Subject: Dynamic Evaluation of Seat Restraint
Systems and Occupant Protection on Transport
Airplanes

AC No: 25.562-1B

Change: 1

2. PRINCIPAL CHANGES. Change 1 updates AC 25.562-1B, *Dynamic Evaluation of Seat Restraint Systems and Occupant Protection on Transport Airplanes*, dated January 10, 2006. We have added the change number and date of revision at the top of each changed page. We have also marked the changes with a vertical change bar in the margin. Specifically, Change 1 incorporates the following changes:

Figure 5-2. Structural Test Article Decision Tree for Seat Family

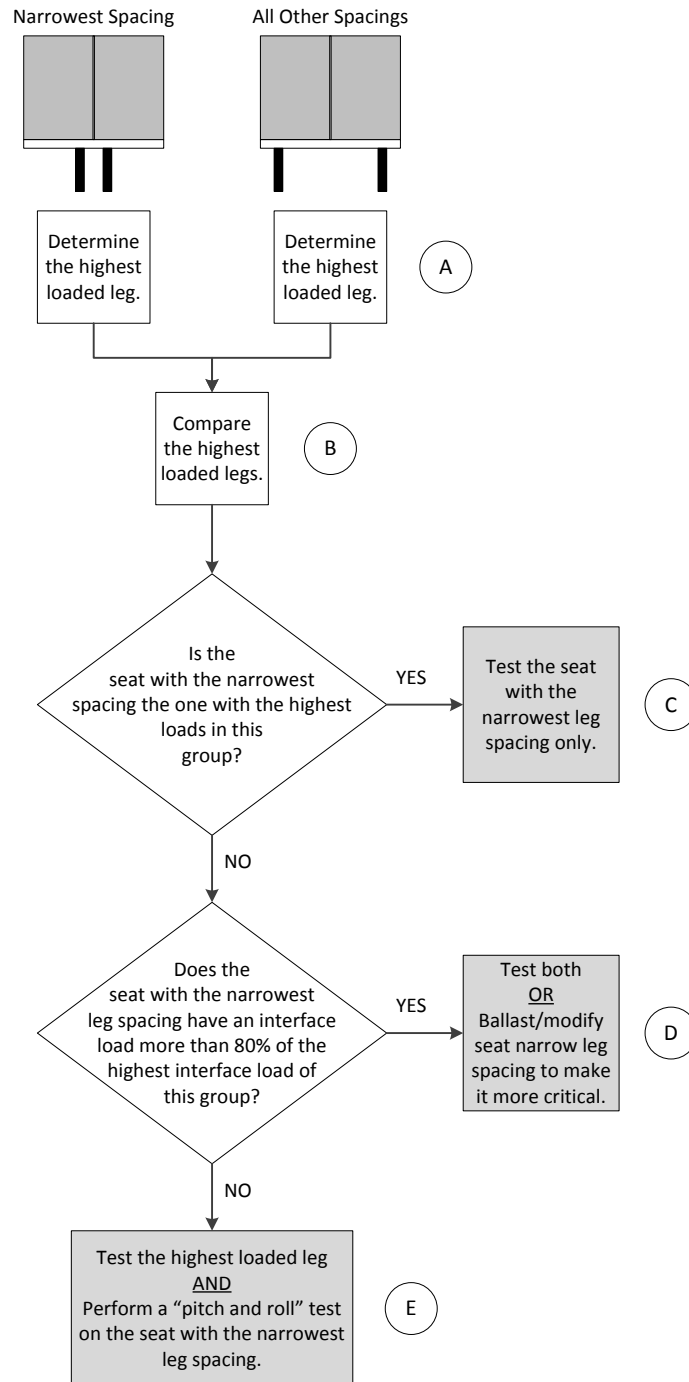
- a. Corrects the figure references in Steps 3 and 3d under paragraph 5d(1).
- b. Corrects typographical errors in the second question of Figure 5-2. We also redesigned the figure to improve readability.
